ARCHITECTURAL REVISIONS - SHEET NOTES

PUD REVISIONS

2229 M STREET NE

ZONING COMMISSION
District of Columbia
CASE NO. Z-2024-0011
EXHIBIT NO. 2C3

A3.10R

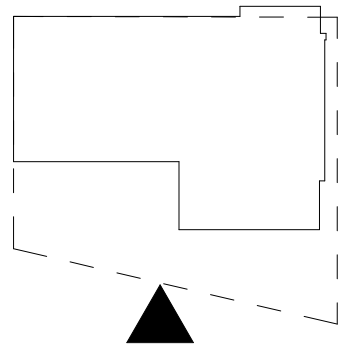
- 1. All Juliet balconies removed.
- 2. Entry terrace size reduced.
- 3. Roof terrace entrance canopy removed.
- 4. Stucco changed to EIFS.
- 5. Window sizes reduced to comply with building code max % and improve interior unit layout.

A3.11R

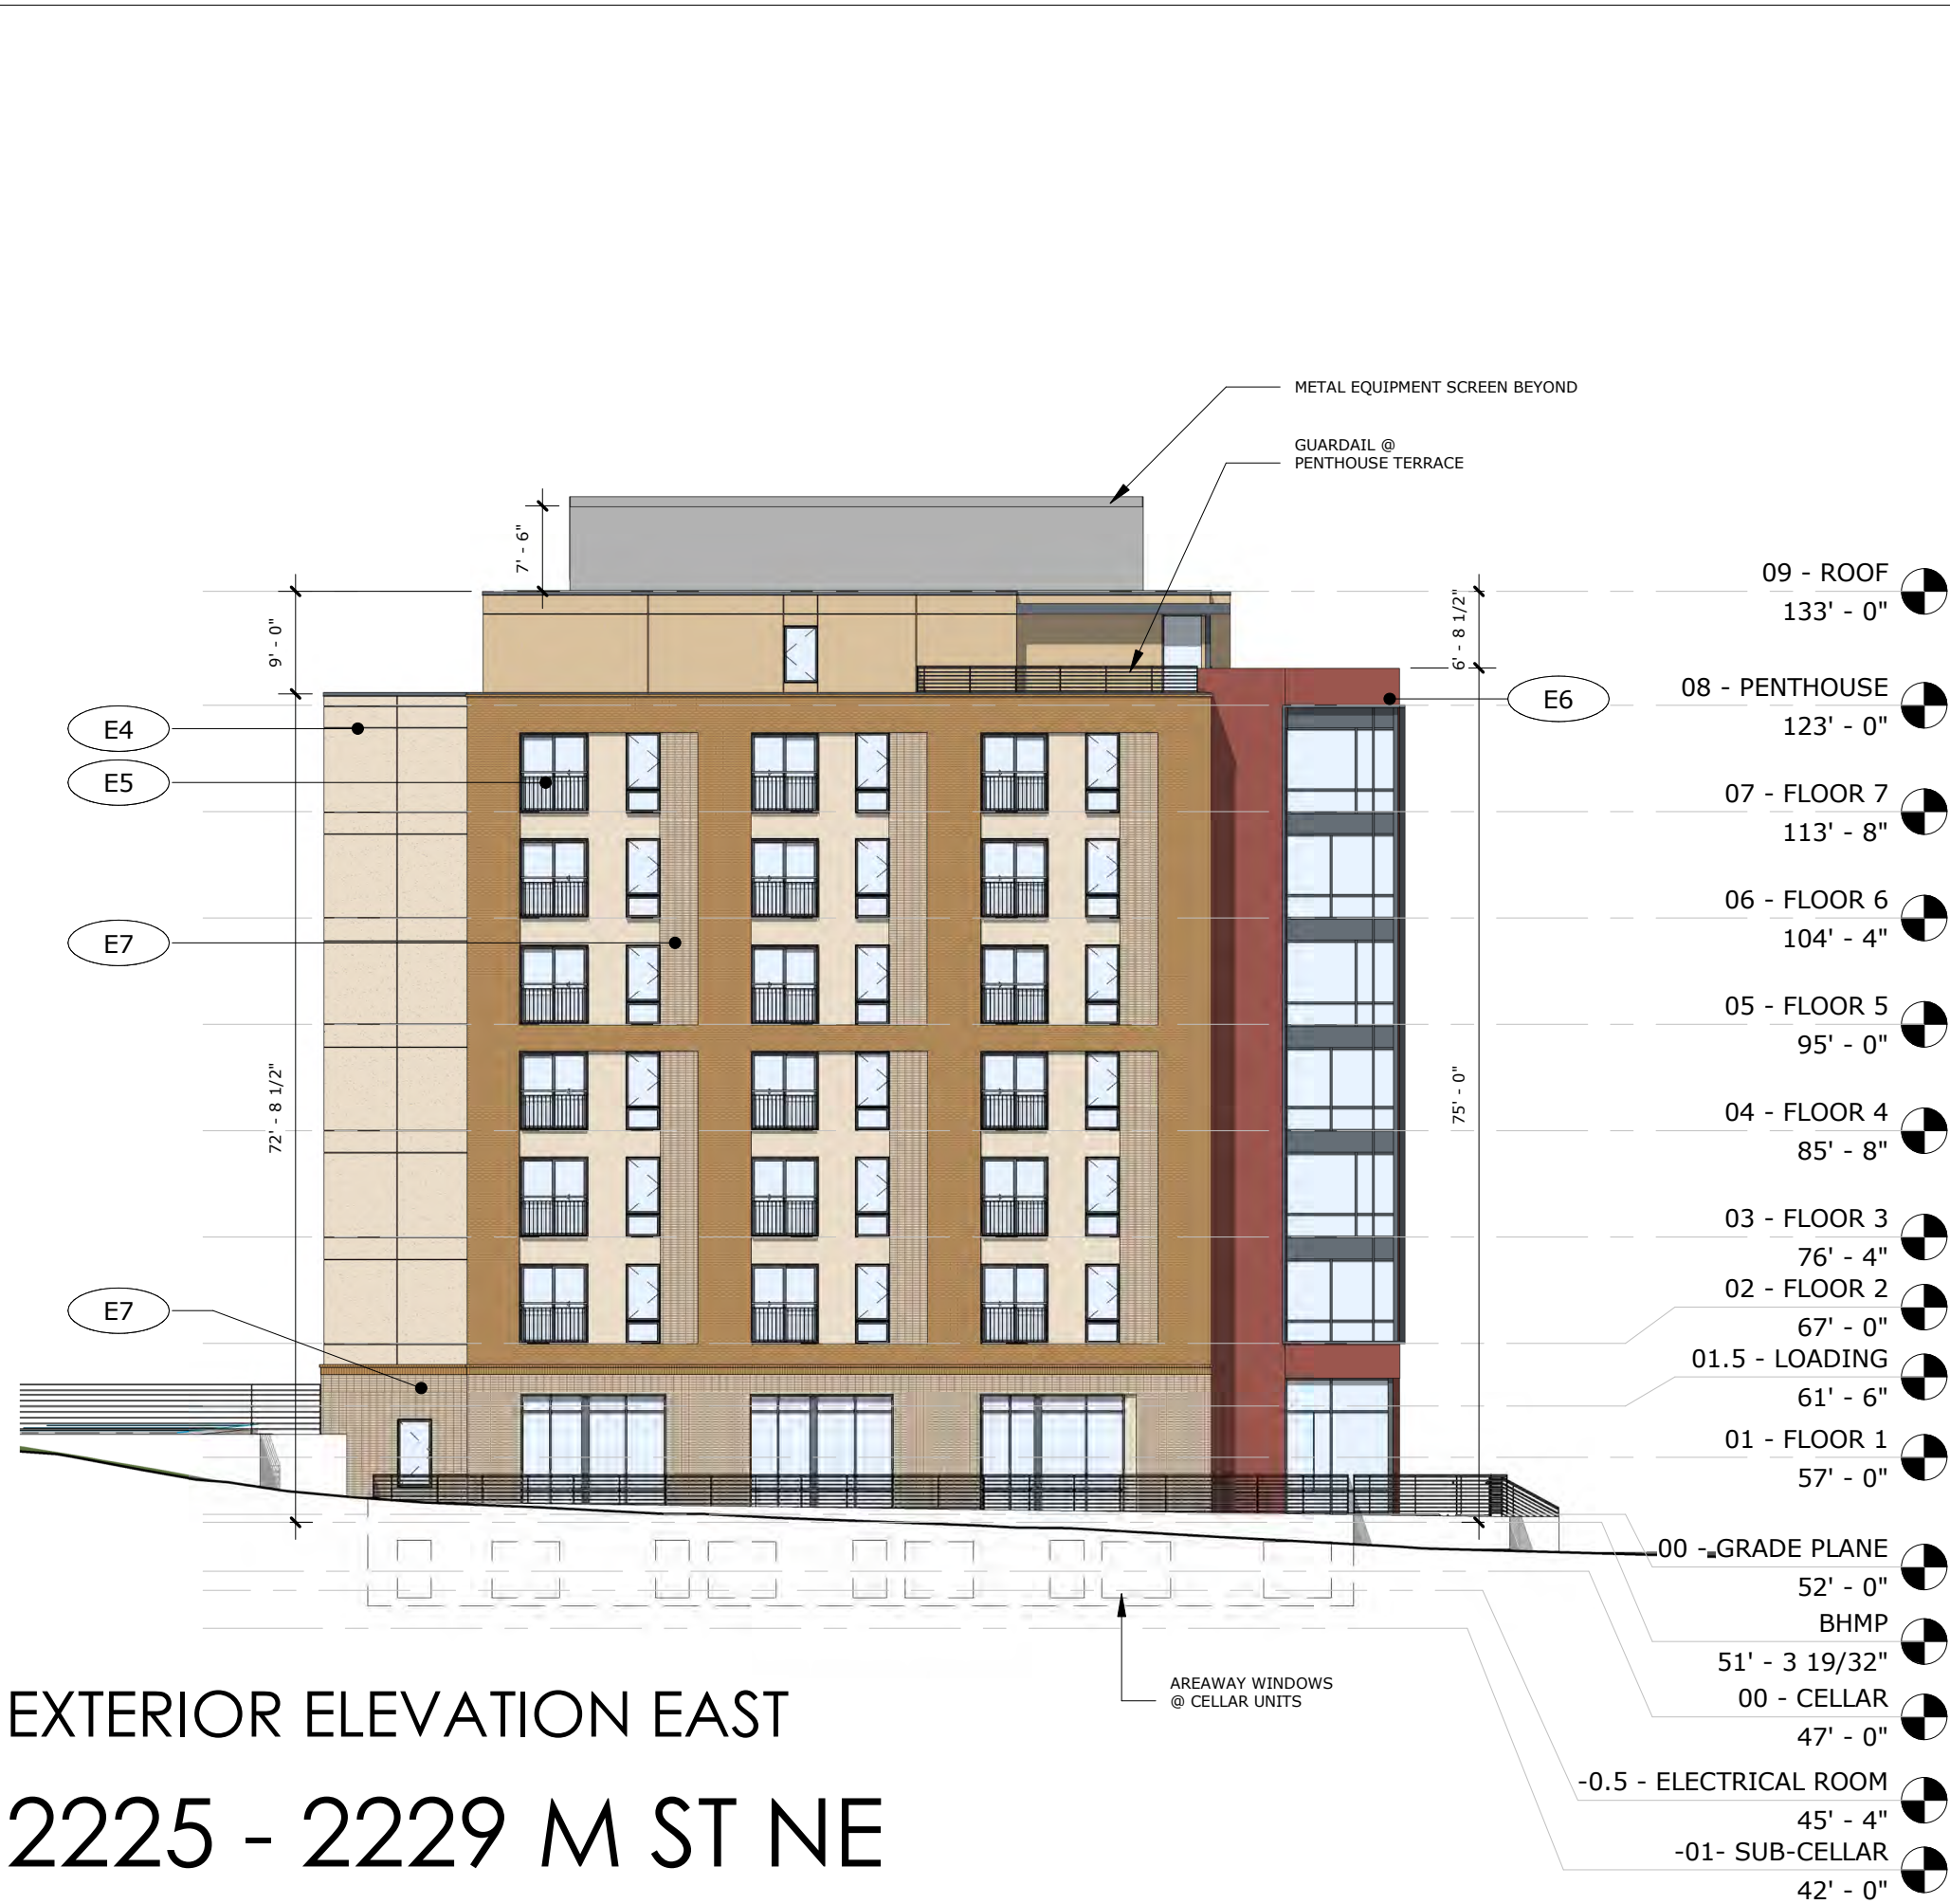
- 1. All Juliet balconies removed.
- 2. Entry terrace size reduced.
- 3. Roof terrace entrance canopy removed.
- 4. Stucco changed to EIFS.
- 5. Window sizes reduced to comply with building code max % and improve interior unit layout.

A3.12R

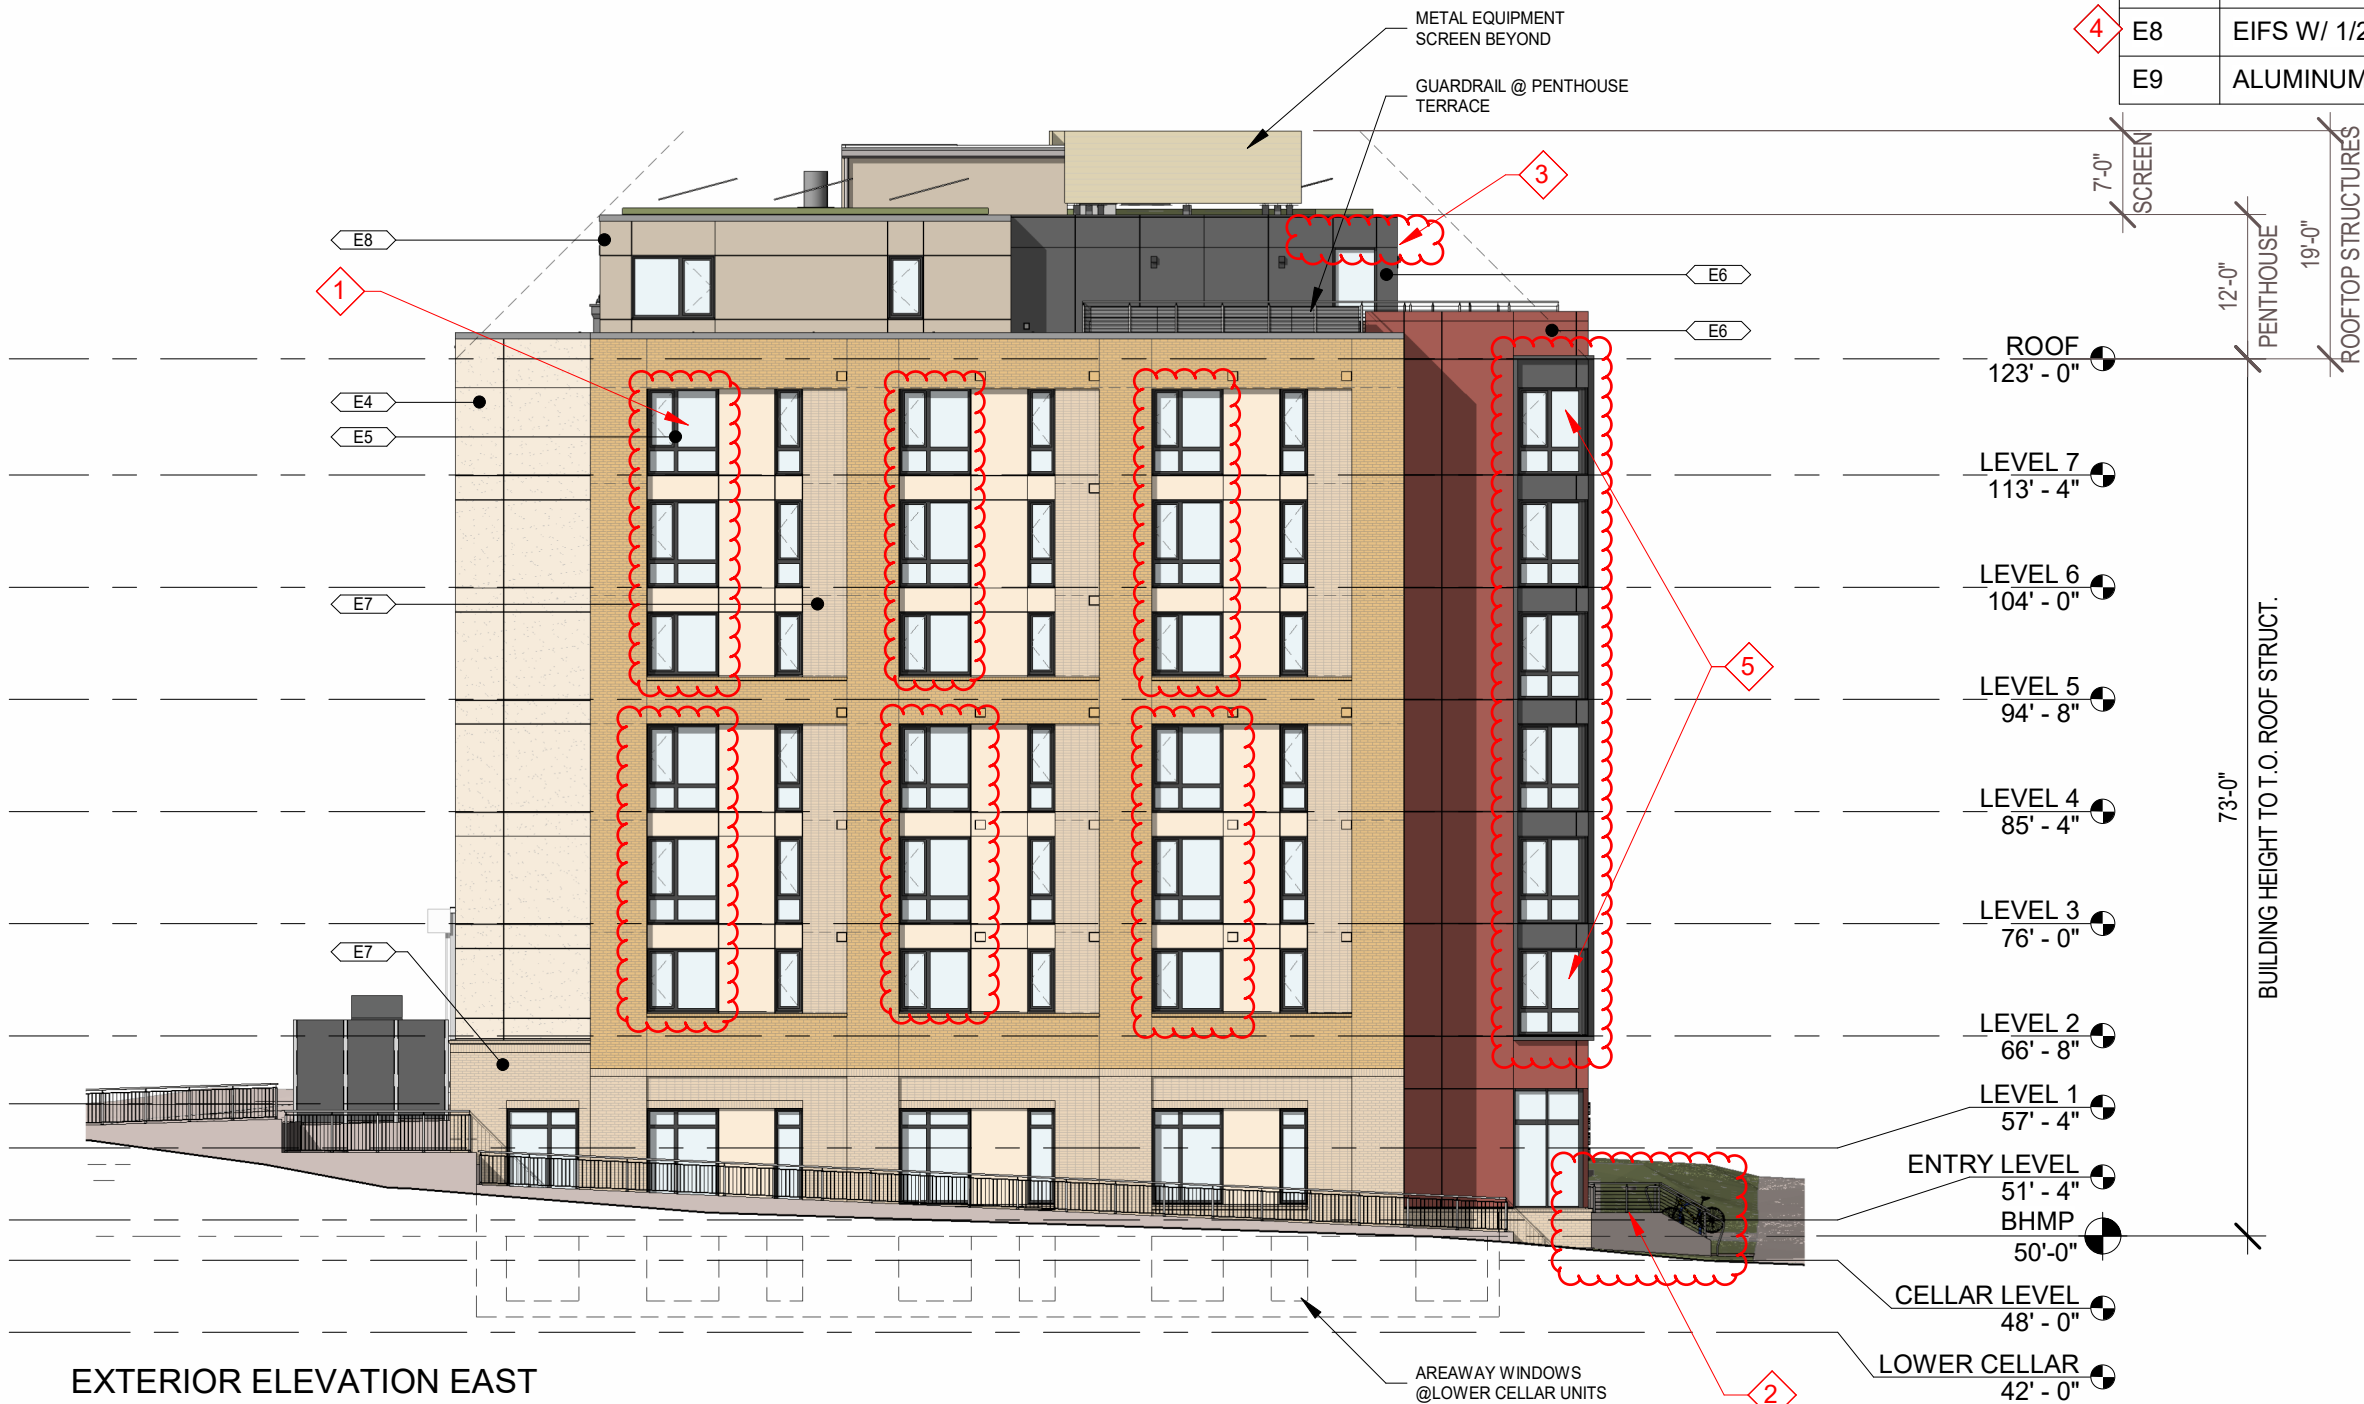
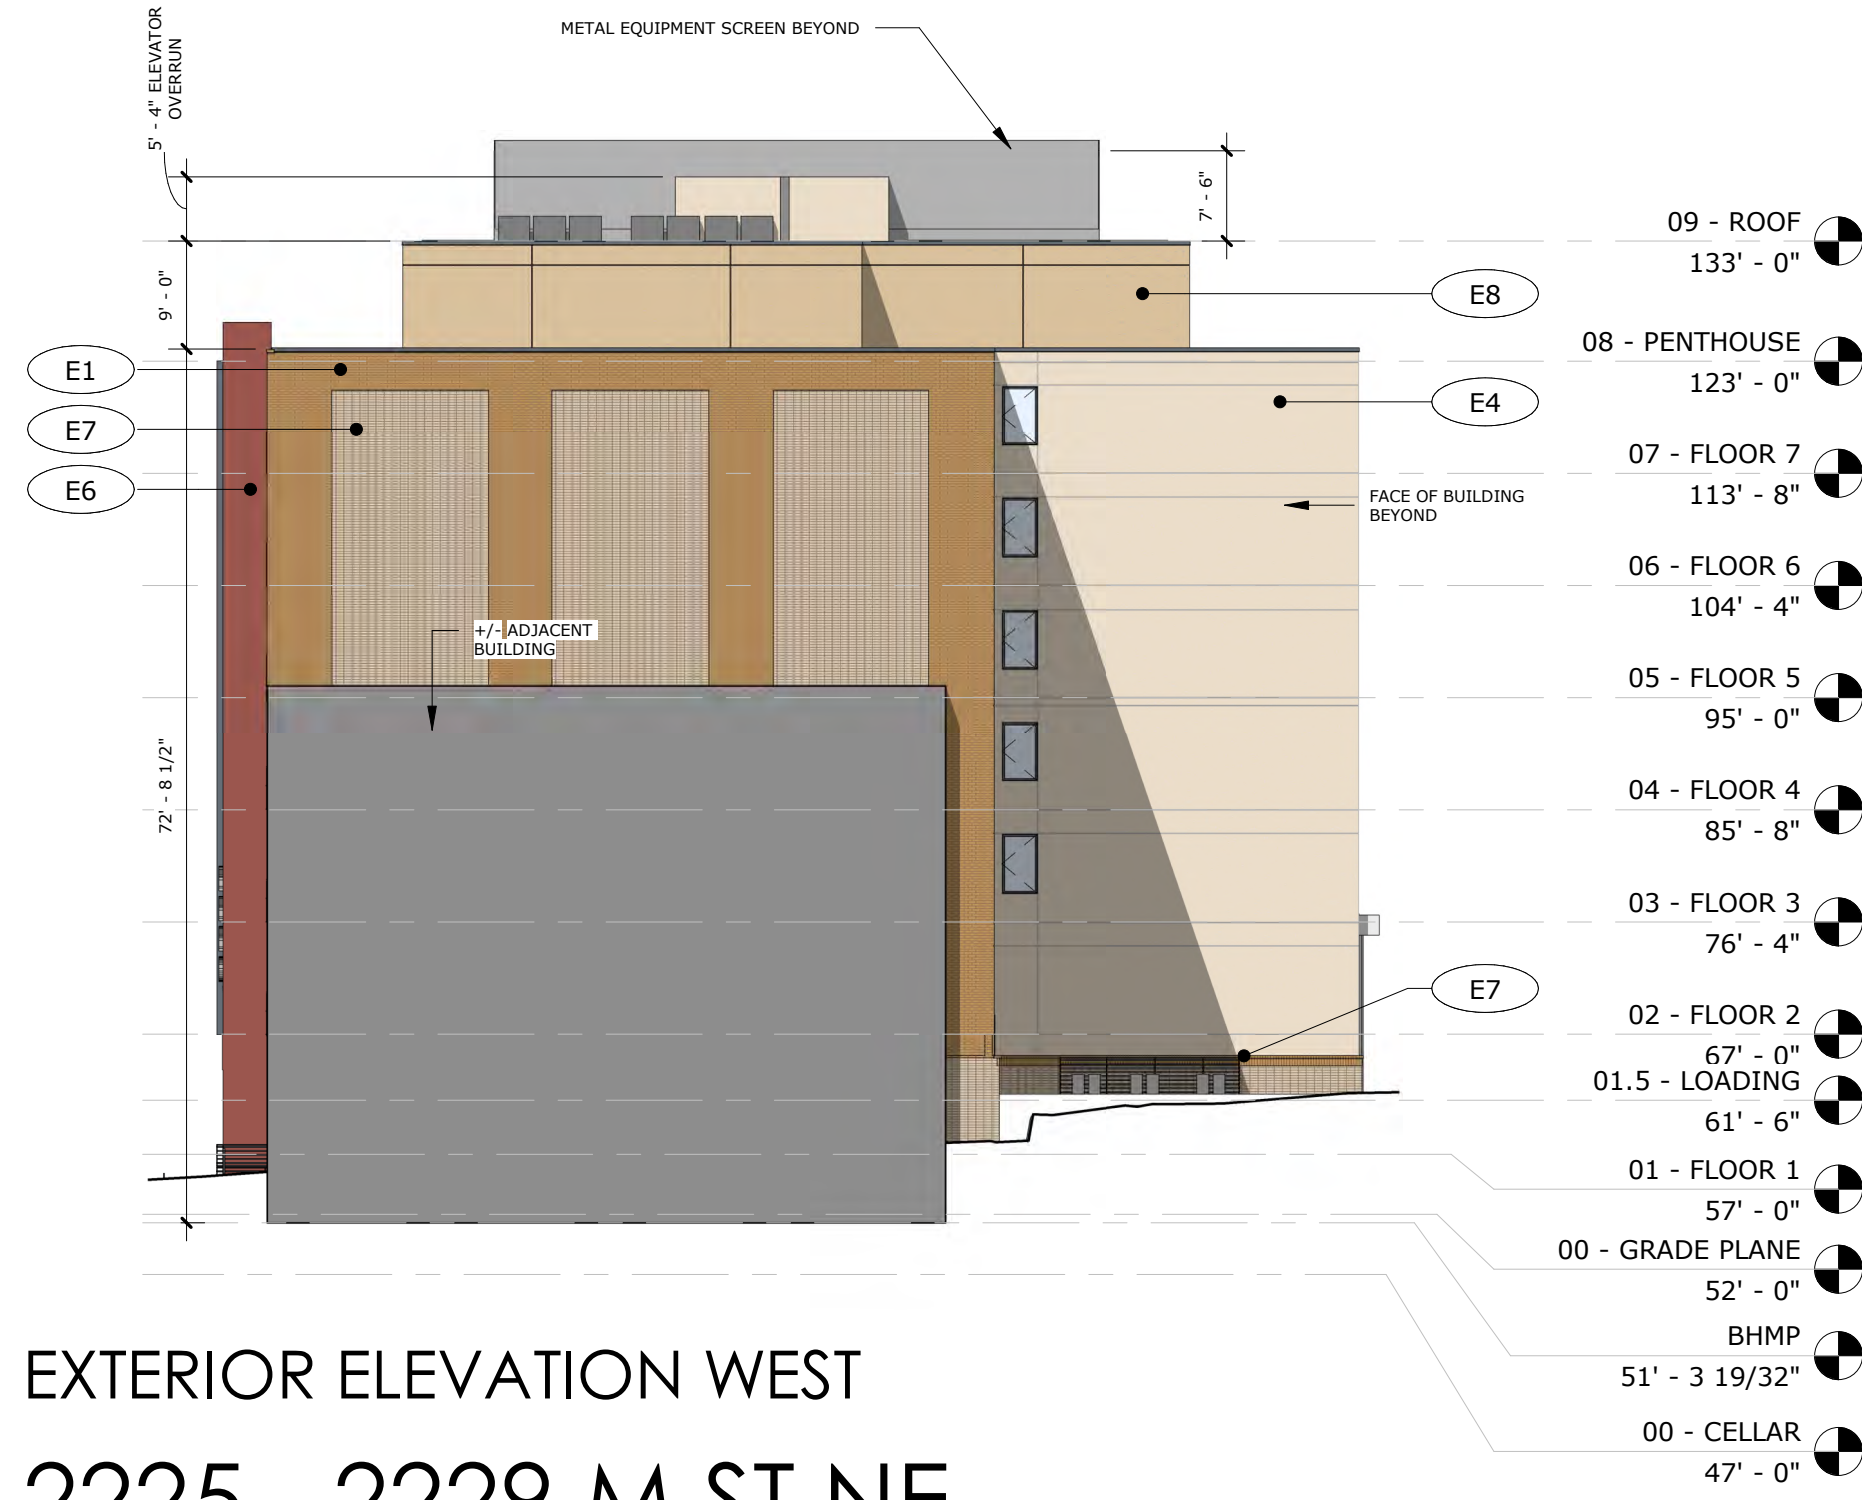
- 1. All Juliet balconies removed.
- 2. Entry terrace size reduced.
- 3. Roof terrace entrance canopy removed.
- 4. Stucco changed to EIFS.
- 5. Window sizes reduced to comply with building code max % and improve interior unit layout.
